SUBJECT: Submits addl info re tendon insp & lift-off verification, in response to NRC 800326 ltr. Also forwards revised pages & tables for GAI-2074, "Evaluation of Prestressed Tendon Forces."

Subject: Tendon Inspection and
Lift-Off Verification
Ginna Nuclear Power Plant
Docket No. 50-244

Basic Creep for 5000 psi Concrete

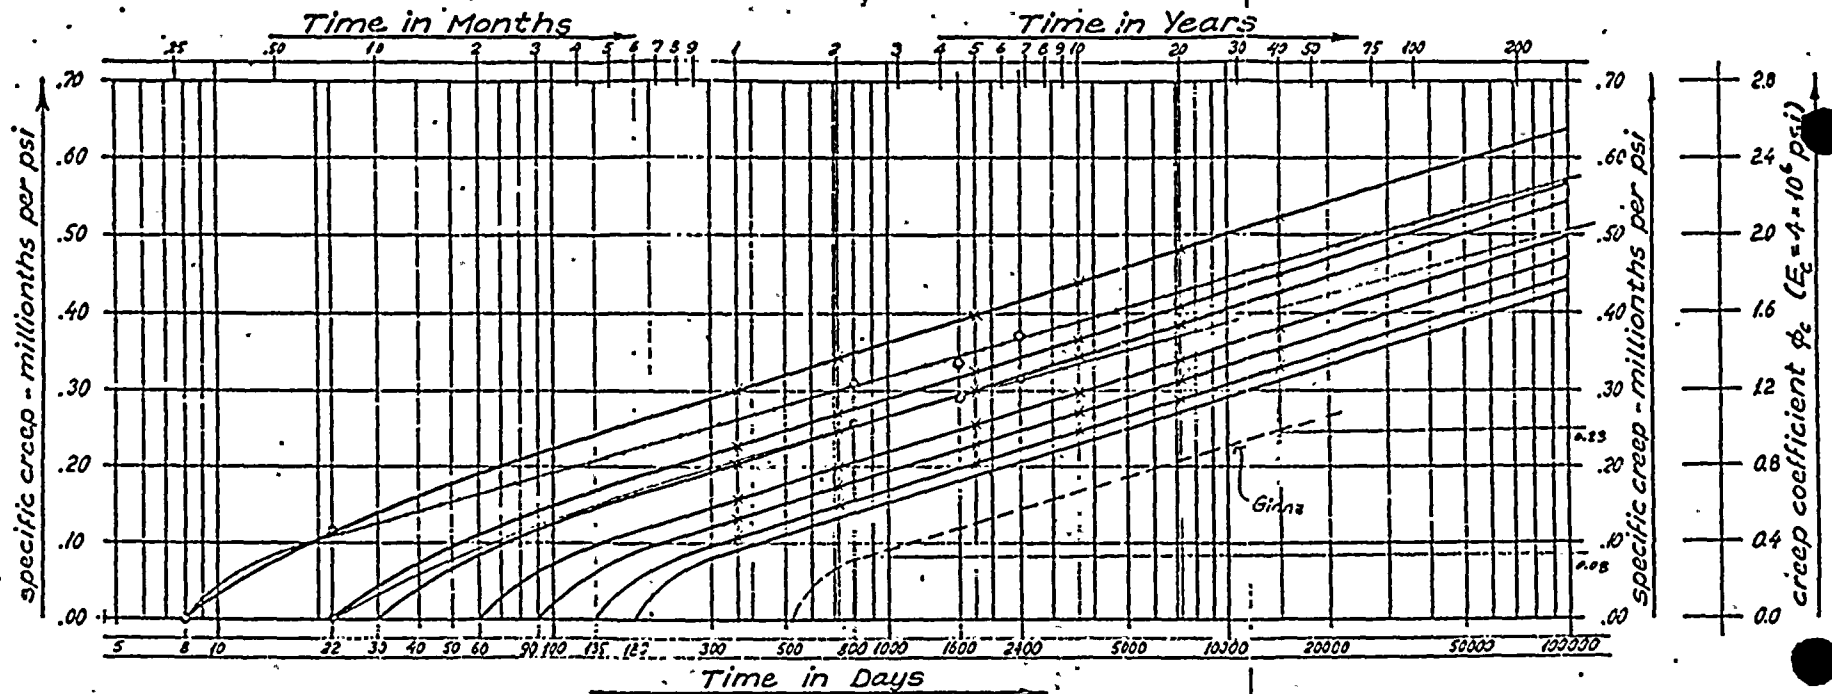
The creep curve of Reference (6) of the report is included as Attachment 2. It was used to establish the specific creep values defined in the report. Independent creep tests were not required for Ginna and were, therefore, not conducted.

The concrete mix design used for the containment wall is given in the response to Question 1. For the Ginna mix, the volume concentration of cement paste in the concrete is 0.34, and the water-cement ratio by weight is 0.45. For Reference (6) these values were 0.30 and 0.50, respectively. Because of the similarity of the two mixes, the specific creep data of Reference (6) is considered applicable to the Ginna concrete.

Figure 1 - Stress-Relaxation Curves for Normal and for Intermediate
.250" Dia. Tufwire

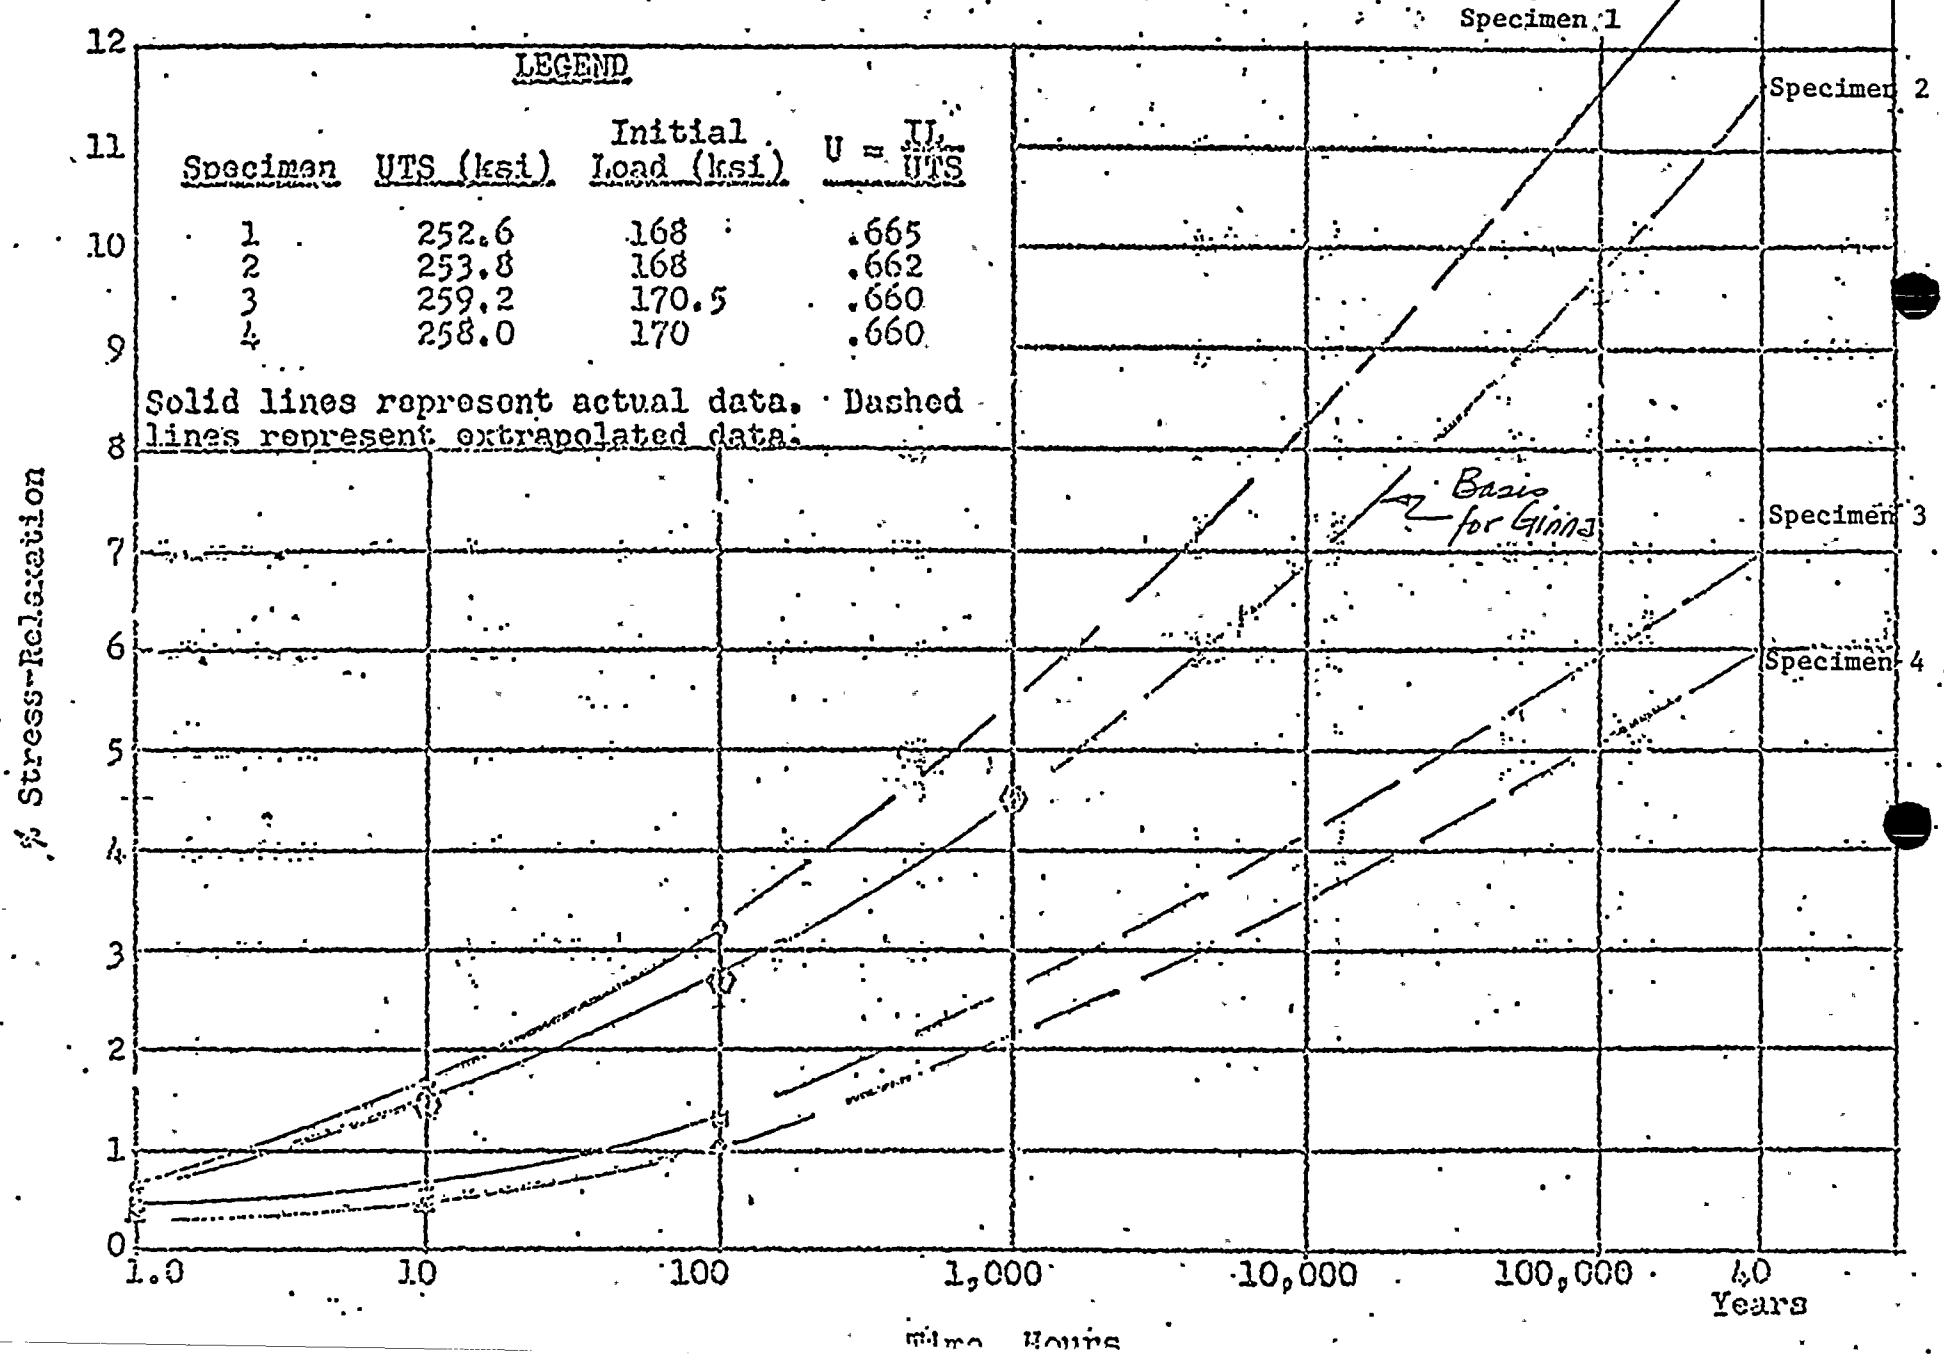
As stated in the report, the prestressing wire was specified to have a nominal 40-year stress relaxation of 12%. Figure 3A of the report is based on stress-relaxation curves from Armco Steel Corporation (See Attachment 3), the supplier of the wire for Ginna. The curves for Specimens 1 and 2 were provided by Armco as being representative of the relaxation grade of wire provided for Ginna, but the specimens were not taken from Ginna production wire. The curve in Figure 3A of the report was constructed by multiplying the relaxation curve for Specimen 2 by the factor (12/11.5). Note that the curve for Specimen 2 includes data from 1000-hour relaxation tests.

Attachment 5

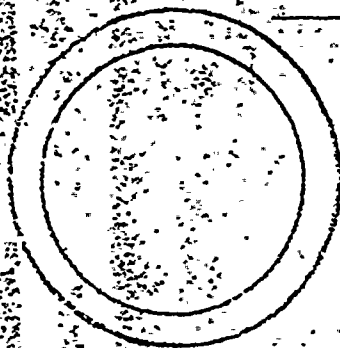
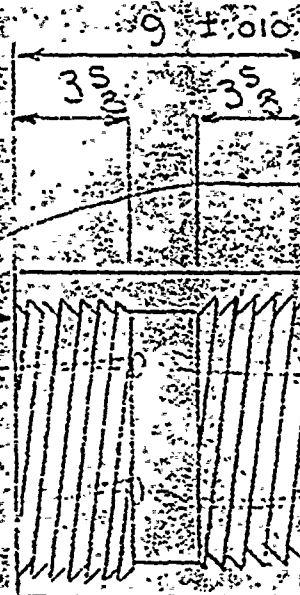
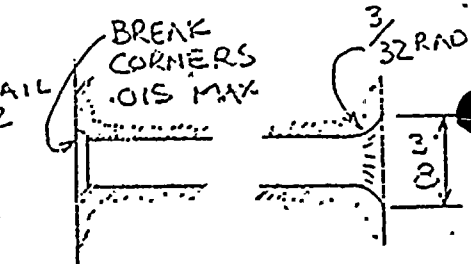
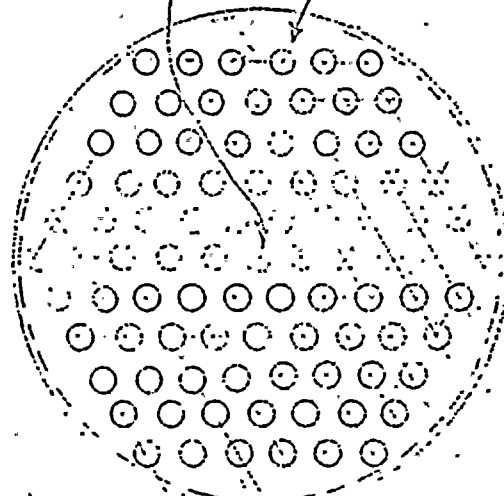
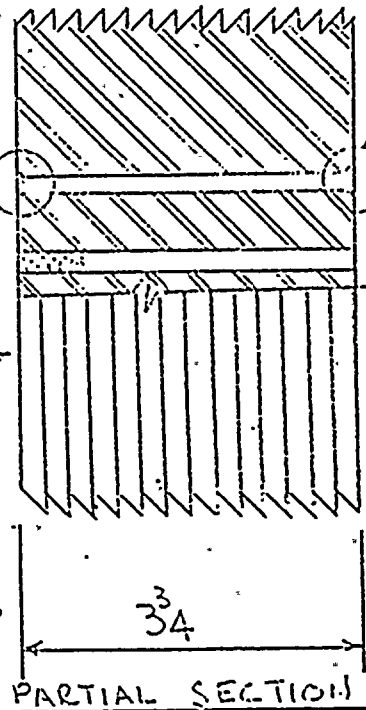
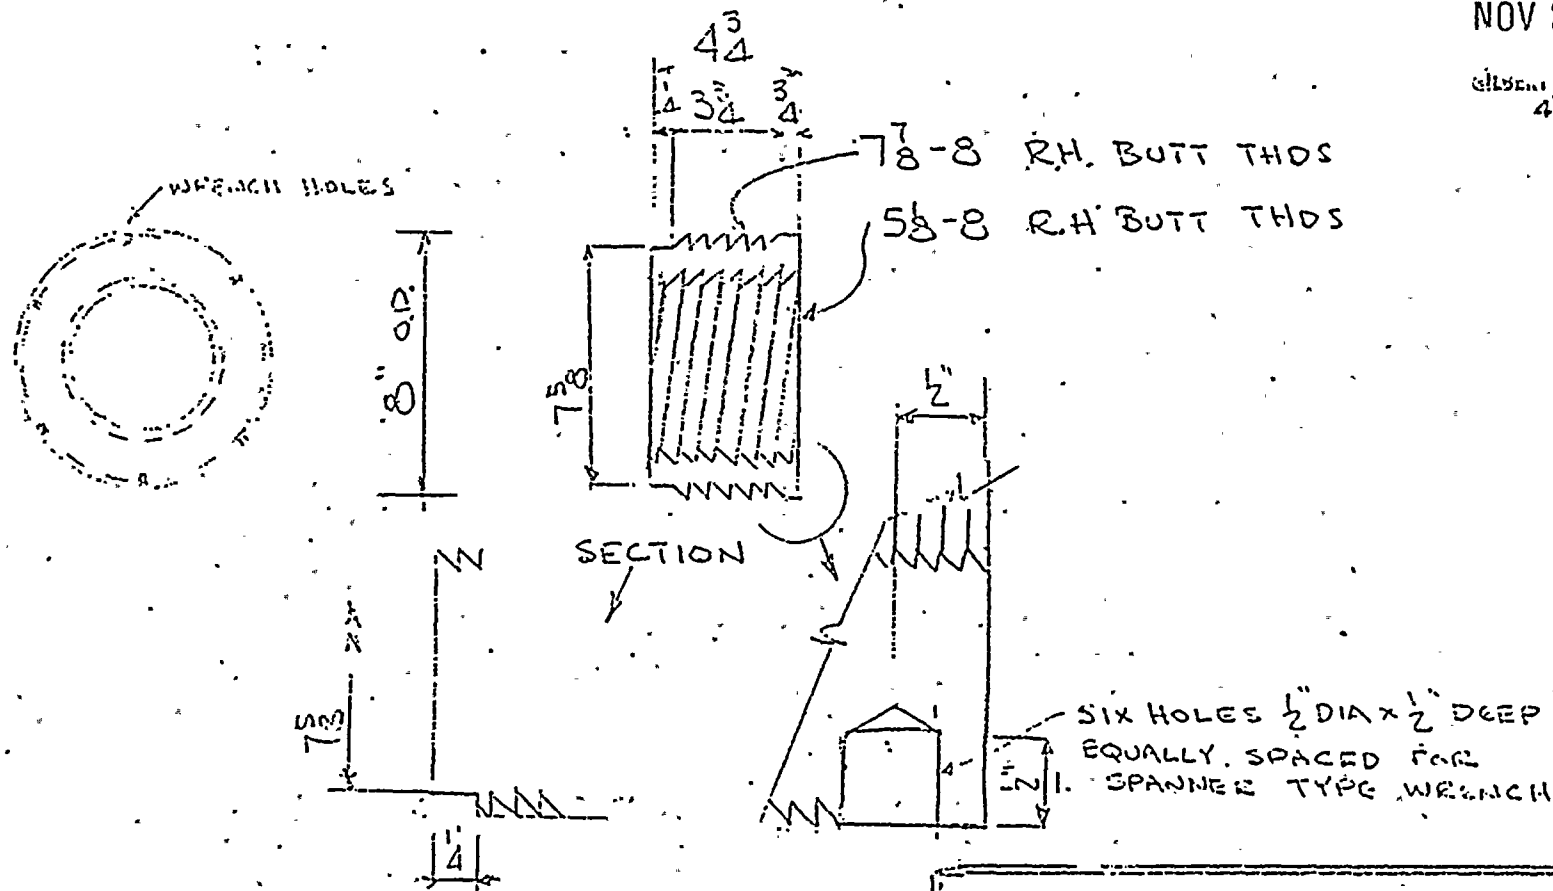
Page 5.1.2-24 of the Ginna FSAR (See Attachment 2, part 6 of the report) describes the technique used to install the tendon/rock anchor coupling device. Attachment 5 is an assembly drawing of the tendon to rock coupling, and the manufacturer's drawings of the individual parts.
